ACCESSIBILITY ASSESSMENT

February 14, 2025

ADA TITLE II ASSESSMENT

Mount Vernon Elementary School
935 Filbert Lane
Springfield, Oregon 97478

Photos for Barrier ID: AX553717

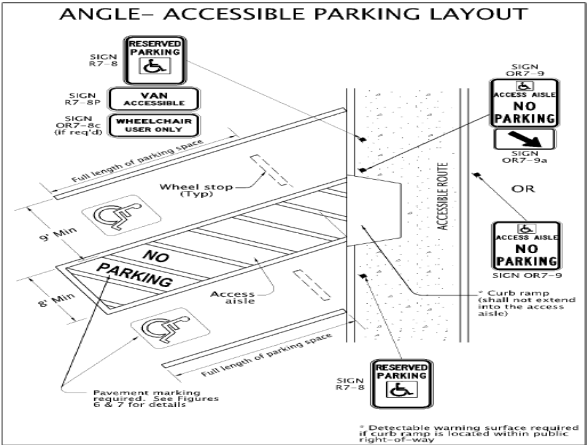
Assembly	Accessible Parking
Type	Parking Space - Van
ADA Standard	502.4
Barrier Detail	The parking space slope is greater than 1:50 (2%).
Location Description	Accessible Parking Space P1-A
Observed	Jan 21, 2025 by Danjo.Ginete@bureauveritas.com
Site Conditions	The van accessible parking space has a running slope of 2.7%.

Remove and replace with a van space which has a slope of maximum 1:50 (2%) in all directions. [EXCEPTION: Slopes not steeper than 1:48 (2.08%) shall be permitted.] Changes in level are not permitted. Parking spaces and access aisles serving them shall be compliant. Width measurements shall be made from the centerline of the markings. [EXCEPTION: Where parking spaces or access aisles are not adjacent to another parking space or access aisle, measurements shall be permitted to include the full width of the line defining the parking space or access aisle.] The quantity and order of magnitude cost estimate provided for this barrier are limited to the extent of the area identified as non-compliant. Additional costs that may be associated with removal of the barrier are not included.

Photos for Barrier ID: AX553763

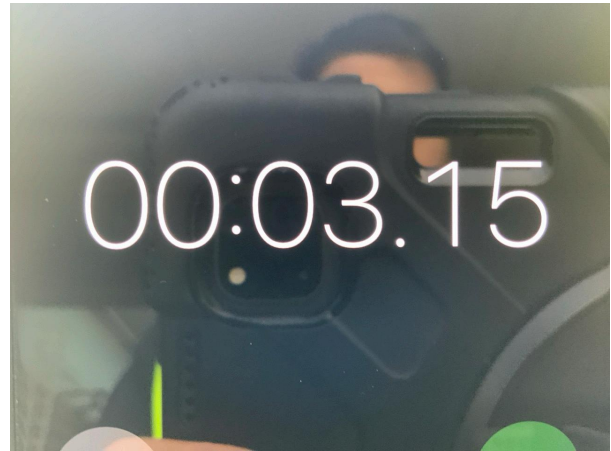
Assembly	Entrance to Building	
Type	Building Entrance - Door	
ADA Standard	404.2.8	
Barrier Detail		
The accessible door with door closer has a sweep period of less than 5 seconds from 90 degrees to a position 12 degrees from latch.		
Location Description	B-Wing	
Observed	Jan 21, 2025 by Danjo.Ginete@bureauveritas.com	
Site Conditions		
The closing speed is 3.15 seconds from 90 degrees to a position 12 degrees from latch.		
Resolution		
Adjust closer or remove and replace closer to ensure that the door has a closure time of at least 5 seconds within 12 degrees of the latch. Door closers and gate closers shall be adjusted so that from an open position of 90 degrees, the time required to move the door to a position of 12 degrees from the latch is 5 seconds minimum.		
Quantity	Unit Cost	Total Cost
1 EA	631.35	\$ 631
Priority	1

Adjust closer or remove and replace closer to ensure that the door has a closure time of at least 5 seconds within 12 degrees of the latch. Door closers and gate closers shall be adjusted so that from an open position of 90 degrees, the time required to move the door to a position of 12 degrees from the latch is 5 seconds minimum.

Photos for Barrier ID: AX553752

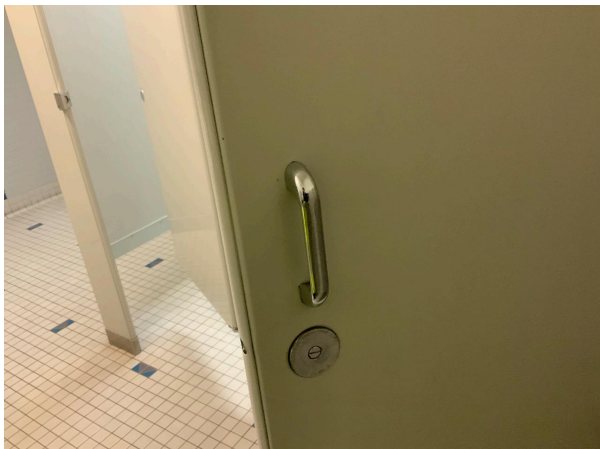
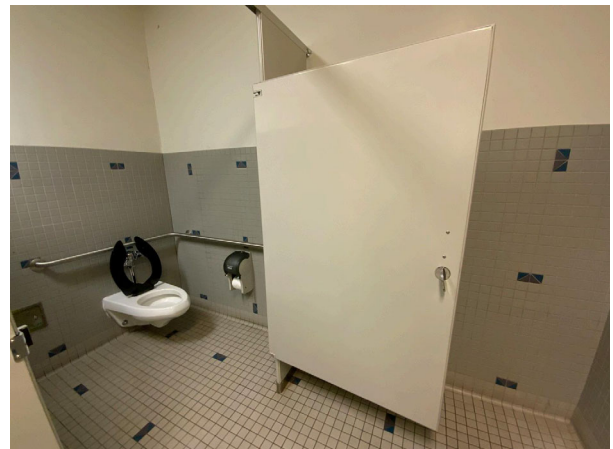
Assembly	Restroom
Type	Restroom/Bathroom-Toilet Stall
ADA Standard	2009 ANSI A117.1-604.5.1 and A117.1-604.9.6
Barrier Detail	
ANSI A117.1-2009 : A vertical side grab bar is not present in the wheelchair stall.	
Location Description	Boy's Restroom
Observed	Jan 21, 2025 by Danjo.Ginete@bureauveritas.com
Site Conditions	A vertical side grab bar is not present in the wheelchair stall.

Resolution		
Install a vertical side grab bar on side wall closest to the toilet. The vertical grab bar shall measure 18" long minimum, mounted 39" to 41" above finish floor. The centerline of the grab bar shall be between 39" and 41" from the rear wall.		
Quantity	Unit Cost	Total Cost
1 EA	612.38	\$ 612
Priority	3

Photos for Barrier ID: AX553753

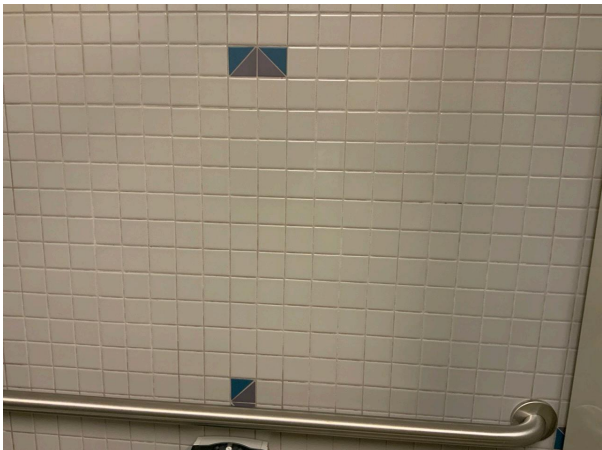
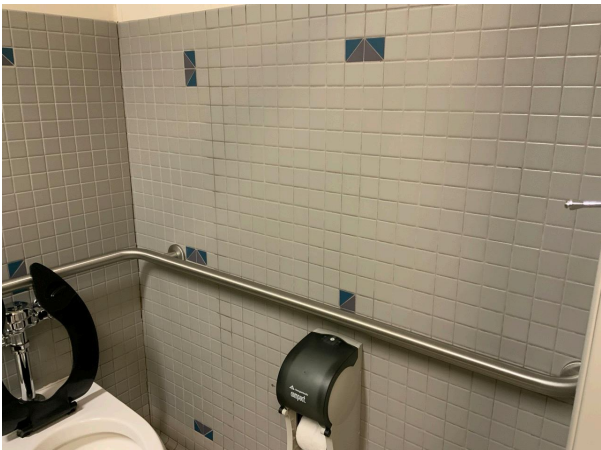
Assembly	Restroom
Type	Restroom/Bathroom-Water Closet
ADA Standard	ADA 604.7, 609.3; 2009 ANSI A117.1-604.7
Barrier Detail	Oregon: The toilet paper dispenser location is not compliant.
Location Description	Boy's Restroom
Observed	Jan 21, 2025 by Danjo.Ginete@bureauveritas.com
Site Conditions	The centerline of the toilet paper dispenser is 10" in front of the water closet.

Photos for Barrier ID: AX553756

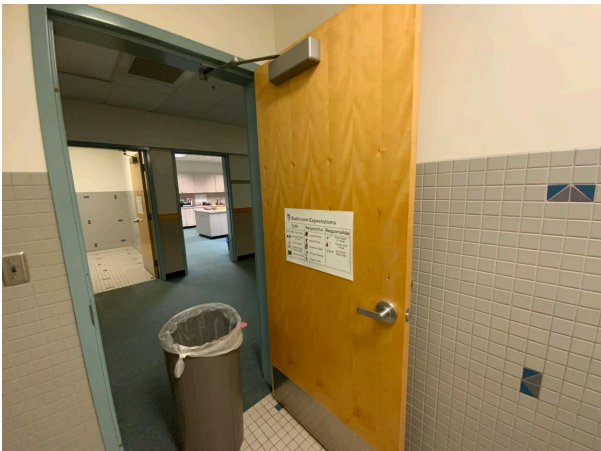
Assembly	Restroom
Type	Restroom/Bathroom - Door
ADA Standard	404.2.9
Barrier Detail	
The force required to open the interior, hinged, non-fire door is more than 5 pounds.	
Location Description	Girl's Restroom
Observed	Jan 21, 2025 by Danjo.Ginete@bureauveritas.com
Site Conditions	The force required to open the interior, hinged, non-fire door is 20 pounds.

Adjust closer or replace with an closer that requires no more 5 pounds of force to stop the door motion. The maximum force for pushing or pulling open a door shall be for interior hinged doors: 5 lbs (22.2N). The force for pushing or pulling open a door or gate other than fire doors shall be as follows: 1. Interior hinged doors and gates: 5 pounds (22.2 N) maximum. 2. Sliding or folding doors: 5 pounds (22.2 N) maximum. These forces do not apply to the force required to retract latch bolts or disengage other devices that hold the door or gate in a closed position. Note: Fire doors shall have a minimum opening force allowable by the appropriate administrative authority.

Photos for Barrier ID: AX553757

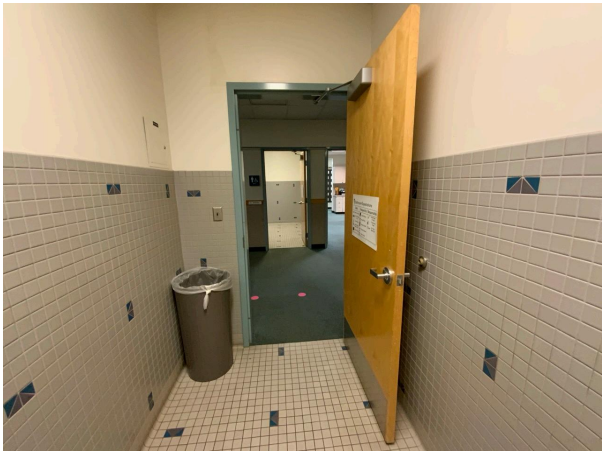
Assembly	Restroom
Type	Restroom/Bathroom - Door
ADA Standard	404.2; Table 404.2.4.1
Barrier Detail	
The pull side of the accessible door does not have the required maneuvering clearances.	
Location Description	Girl's Restroom
Observed	Jan 21, 2025 by Danjo.Ginete@bureauveritas.com
Site Conditions	The trash can is in the required maneuvering clearance at the door.

Relocate furniture to provide the required maneuvering clearance at the pull side of the door. The required depth of the maneuvering clearance is 60" minimum. The required side clearance is 18" minimum on the latch side of the door. Maneuvering clearance shall extend the full width of the doorway and the required latch side clearance. Floor or ground space within the required maneuvering clearance shall be maximum 1:48 (2.08%) slope. Changes in level are not permitted.

Photos for Barrier ID: AX553759

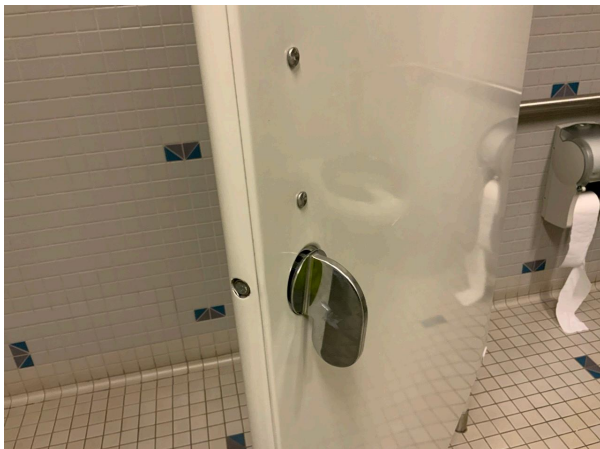
Assembly	Restroom
Type	Restroom/Bathroom - Toilet Stall
ADA Standard	309, 404.2.7, 604.8.1.2
Barrier Detail	The wheelchair stall door is not compliant.
Location Description	Girl's Restroom
Observed	Jan 21, 2025 by Danjo.Ginete@bureauveritas.com

Toilet compartment doors for wheelchair stalls, including door hardware, shall comply except that if the approach is to the latch side of the compartment door, clearance between the door side of the compartment and any obstruction shall be 42" minimum. Doors shall be located in the front partition or in the side wall or partition farthest from the water closet. Where located in the front partition, the door opening shall be 4" maximum from the side wall or partition farthest from the water closet. Where located in the side wall or partition, the door opening shall be 4" maximum from the front partition. The door shall be self-closing. A compliant door pull shall be placed on both sides of the door near the latch. Toilet compartment doors shall not swing into the minimum required compartment area, 60" wide minimum measured perpendicular to the side wall, and 56" deep minimum for a wall hung water closet or 59" deep minimum for a floor mounted water closet measured perpendicular to the rear wall.

Photos for Barrier ID: AX553760

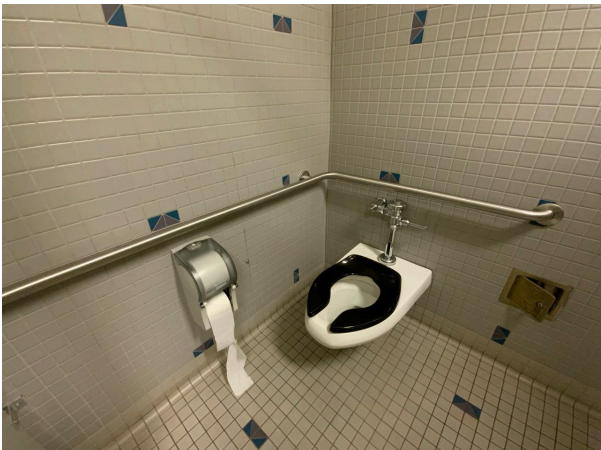
Assembly	Restroom
Type	Restroom/Bathroom
ADA Standard	2009 ANSI A117.1-604.5.1 and A117.1-604.9.6
Barrier Detail	
ANSI A117.1-2009 : A vertical side grab bar is not present in the wheelchair stall.	
Location Description	Health Restroom
Observed	Jan 21, 2025 by Danjo.Ginete@bureauveritas.com
Site Conditions	A vertical side grab bar is not present in the wheelchair stall.

Photos for Barrier ID: AX553762

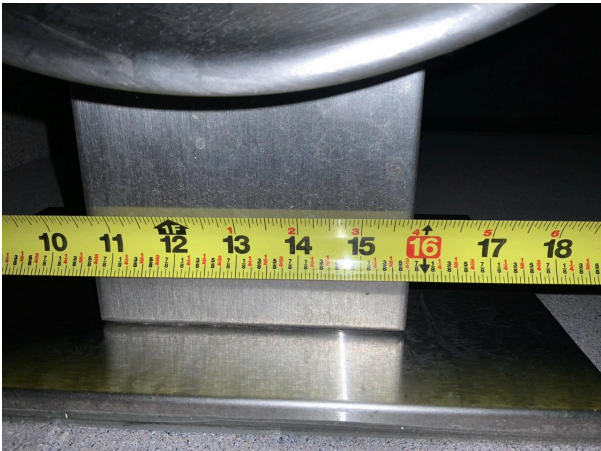
Assembly	Common Areas	
Type	Work Surface	
ADA Standard	306, 902.1, 902.2, 902.3, 902.4	
Barrier Detail		
The work surface height is not compliant. Knee and toe clearances are not provided.		
Location Description	Breakroom	
Observed	Jan 21, 2025 by Danjo.Ginete@bureauveritas.com	
Site Conditions		
The knee clearance for the table at is 26" from the finish floor. A minimum of one accessible table is required.		
Height	26"	
Resolution		
Provide work surface tables at a compliant height. The tops of work surfaces shall be 28" minimum and 34" maximum above the finish floor or ground. A clear floor space 30" minimum by 48" minimum, positioned for a forward approach with the 30" dimension paralleling the edge of the work surface, shall be provided. Knee and toe clearance shall be provided. Knee Clearance: Space under an element between 9" and 27" above the finish floor or ground shall be considered knee clearance. Knee clearance shall extend 25" maximum under an element at 9" above the finish floor or ground. Where knee clearance is required under an element as part of a clear floor space, the knee clearance shall be 11" deep minimum at 9" above the finish floor or ground, and 8" deep minimum at 27" above the finish floor or ground. Between 9" and 27" above the finish floor or ground, the knee clearance shall be permitted to reduce at a rate of 1" in depth for each 6" in height. Knee clearance shall be 30" wide minimum. Toe Clearance: Space under an element between the finish floor or ground and 9" above the finish floor or ground shall be considered toe clearance. Toe clearance shall extend 25" maximum under an element. Where toe clearance is required at an element as part of a clear floor space, the toe clearance shall extend 17" minimum under the element. Space extending greater than 6" beyond the available knee clearance at 9" above the finish floor or ground shall not be considered toe clearance. Toe clearance shall be 30" wide minimum. Examples of work surfaces include writing surfaces, study carrels, student laboratory stations, baby changing, other tables or fixtures for personal grooming.
